Re: Tres Laurels

**MDP # 010-07**

# TRES LAURELS

A MASTER PLANNED RESIDENTIAL COMMUNITY  
MASTER DEVELOPMENT PLAN

MDP  
010-07

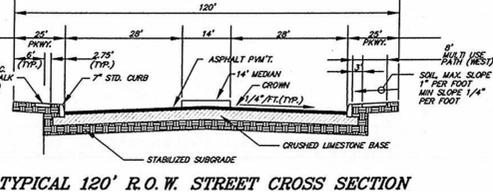
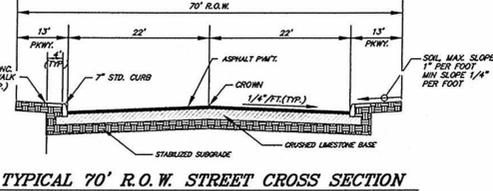
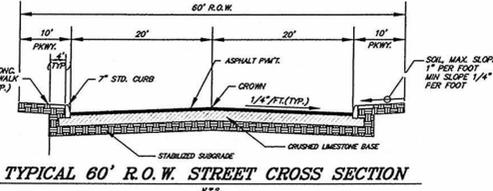
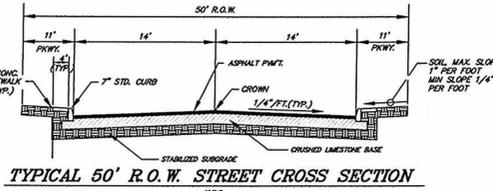
In consideration of public safety and convenience, excessive grades by reason of topography should be avoided in street layouts and arrangements. Any access and right-of-way issues along state facilities will need to be resolved with the Texas Department of Transportation (TXDOT). For information about these requirements you can contact TXDOT at 615-5814.

**Parks and Recreation** indicates Tres Laurels MDP proposes 956 single family units. The requirement for this development is 13.7 acres. This subdivision provides 24.6 acres of park/open space dedication.

- The parkland provided shall be shown as "Park" or "Open Space" on a plat; Unified Development Code (UDC) section 35-503(e) *Designation of Parkland*.
- The parkland provided shall be dedicated to the Home Owners Association.
- The instruments creating the Home Owners Association shall be provided by the second application for plat approval; UDC section 35-503(e) *Designation of Parkland*.
- Parkland dedication must be platted by the second phase of residential development; UDC section 35-503(f) *Development Phasing*.

- 2006 Tree Preservation ordinance standards per UDC Section 35-523 – a Tree Preservation Plan is required prior to any work on site. This can be submitted either as a

site work permit or at the platting stage. Additional permitting fees and affidavits will be needed to obtain tree permits during the platting and/or site work permit stages.

- Streetscape standards per UDC Section 35-512 - The new ROW collector will require streetscaping.

**Bexar County Infrastructure Services Department** indicates access will be provided throughout the extension of the existing Montgomery Road as a Primary Arterial Type A roadway to the north boundary of the property, the following improvements must be provided by the developer prior to completion of the Tres Laurels Development:

- Secondary access must be constructed to the arterial roadway with or prior to the approval of any plat or combination of plats exceeding 125 dwelling units as per UDC 35-506(e)(7).
- Traffic controls shall be warranted as per the Texas Manual on Uniform Traffic Control Devices and approved by Bexar County.
- Residential lots shall not side against an arterial road in order to maintain safe corner clearance for residential driveways.
- The configuration of roadways and lots shown adjacent to the flood plain are subject to change based on the results of a more comprehensive flood study.

It is understood that this MDP is a conceptual plan and controlled access should be maintained in order to uphold safe and efficient traffic flow. All access shall comply with the minimum requirements set forth by the Unified Development Code and within the guidelines of the American Association of State Highway and Transportation Officials. Bexar County reserves the right to address driveways, street design, sight distance, ADA requirements, drainage, and floodplain issues at time of platting.

The Texas Sites Atlas indicates that no archaeological sites have been previously identified within the above referenced property. However, the property may contain sites, some of which may be significant. Thus, before any work that might affect any sites is begun we recommend that a qualified professional conduct an archaeological investigation of the property.

All platting shall comply with the Unified Development Code (UDC), Master Plan, and Major Thoroughfare Plan for the City of San Antonio. It will be expected that all of the property depicted in your Master Development Plan to include floodplains, drainage areas, and open

space shall be platted. It is suggested to work closely with the school district, so they can plan accordingly.
